MEMORANDUM

SUBJECT: National Remedy Review Board Recommendations for the San Jacinto River Waste Pits Superfund Site

FROM: Amy R. Legare, Chair
National Remedy Review Board

Figure 3-4
Spatial Distribution of Predicted Net Sedimentation Rate for
21-Year Period: Pre-TCRA Base Case Simulation
Feasibility Study
San Jacinto River Waste Pits Superfund Site

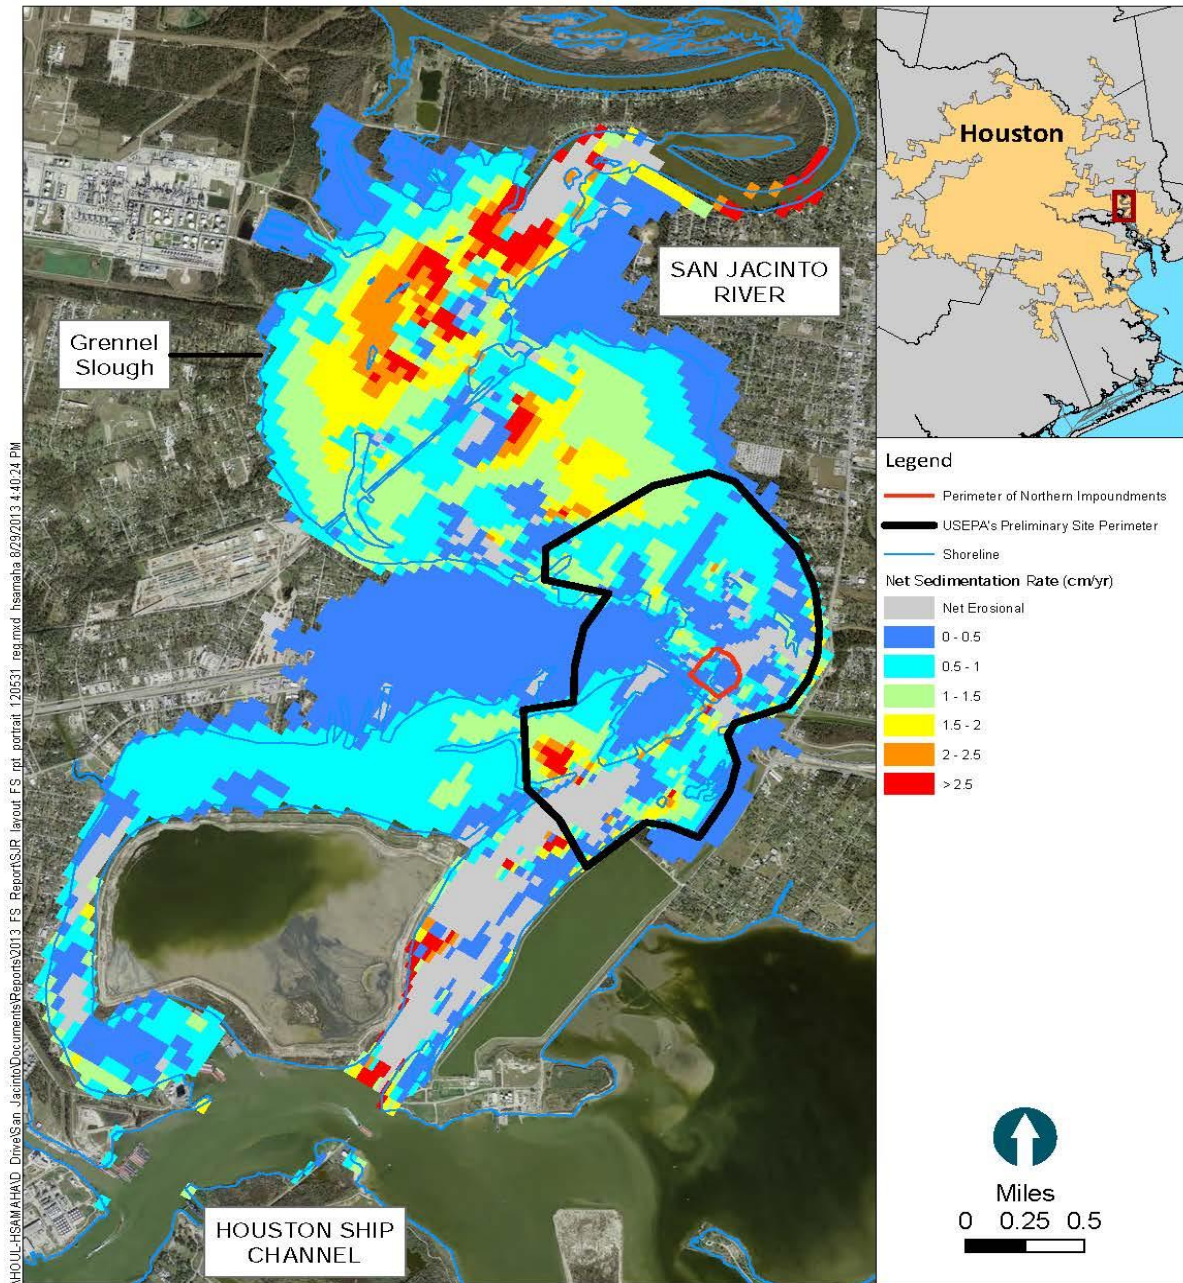
In the package presented to the Board, monitored natural recovery (MNR) is being considered to address contamination in the aquatic environment north of Interstate-10. However, the package did not include an evaluation of MNR's efficacy relative to reaching the relevant RAOs. Given the effects of storms on sediments, it is unclear whether MNR (e.g., by facilitating a covering of cleaner sediments) can be relied upon as a remedial component. The Board recommends that the Region include in the decision documents information on where MNR may be used and an evaluation as to how aquatic conditions (deposition, erosion) in those areas will affect the remedy's protectiveness and future permanence.

Spatial distributions of predicted net sedimentation rates (NSRs) for the long-term simulation period for pre- (i.e., the sediment transport model calibration) and post-TCRA conditions as shown on Figures 3-4 and 3-5 (Appendix A of the FS), respectively are shown below.

Model-predicted future rates of natural recovery in surface sediments, including the range of model uncertainty, were evaluated at various spatial scales over the Model Study Area. Figure 3-18 from Appendix A of the Feasibility Study shown below presents a time series of model-predicted surface (0- to 6-inch) sediment TCDD concentrations averaged over the Preliminary Site Perimeter. The figure shows a base case predicted decrease in TCDD concentration of approximately 75 percent over the Future Projection Period (decreasing from an initial TCDD concentration of approximately 8 nanograms per kilogram [ng/kg] to 2 ng/kg by Year 21). To quantify the rate of decline, an exponential decay curve was fit through the model results, and the rate of decline was calculated (see example for the base case simulation shown as a dotted line on Figure 3-18); the model-predicted decline of TCDD in surface sediment concentrations within the Preliminary Site Perimeter corresponds to a half-life of 11 years.

For the uncertainty simulations, the predicted decline ranged from more than 85 percent (Fate Uncertainty 1) to 40 percent (Fate Uncertainty 4), corresponding to half-lives that vary by about a factor of 2 from the base case, ranging from 7 years to 24 years. The faster rates of natural recovery predicted for the Fate Uncertainty 1 simulation are a result of a combination of increased sedimentation rates and decreased mixing within the bed for this simulation. Conversely, the slower rates of recovery predicted for the Fate Uncertainty 4 simulation are a result of lower sedimentation and increased mixing within the bed.
